HARDEE POWER PARTNERS

**Re: Request for Additional Information
Hardee Power Station – Title V Permit Revision
DEP File No. 0490015-003-AV**

Re: Request for Additional Information Regarding Title V Permit Revision Application
File No. 0490015-003-AV
Hardee Power Station, Hardee County

ATTACHMENT I
GE PERFORMANCE CURVES FOR CT2B

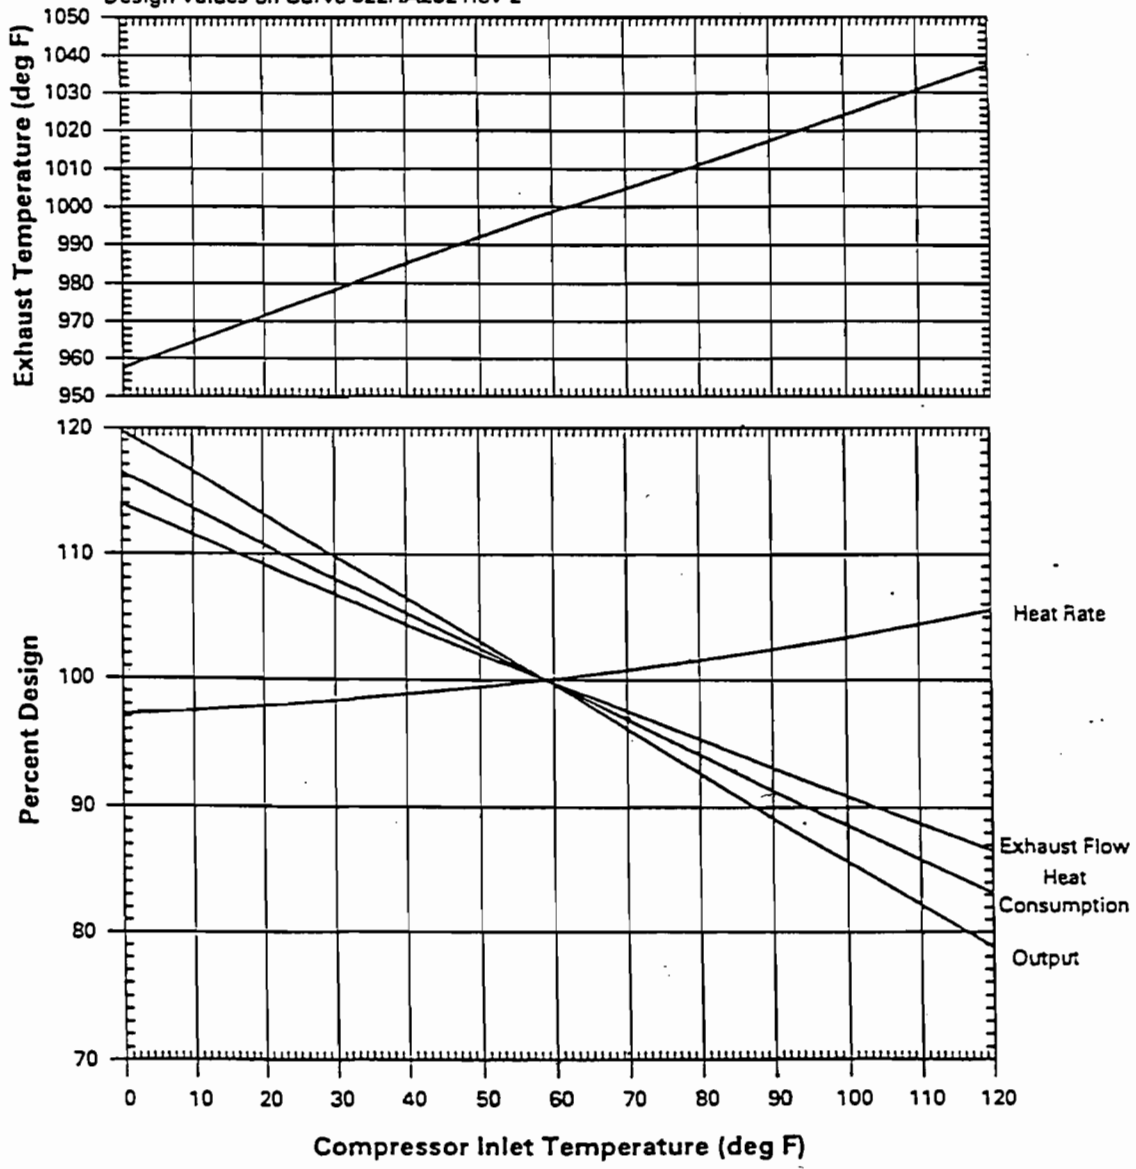
FDEP Item 1: Manufacturer's Performance Curves

1. Manufacturer's performance curves, corrected for site conditions or equations for correction to other ambient conditions for this combustion turbine, Unit CT2B, were not a part of the Title V permit application. Please provide them.

Performance curves provided by General Electric for the Model 7EA combustion turbine are included as Attachment I.
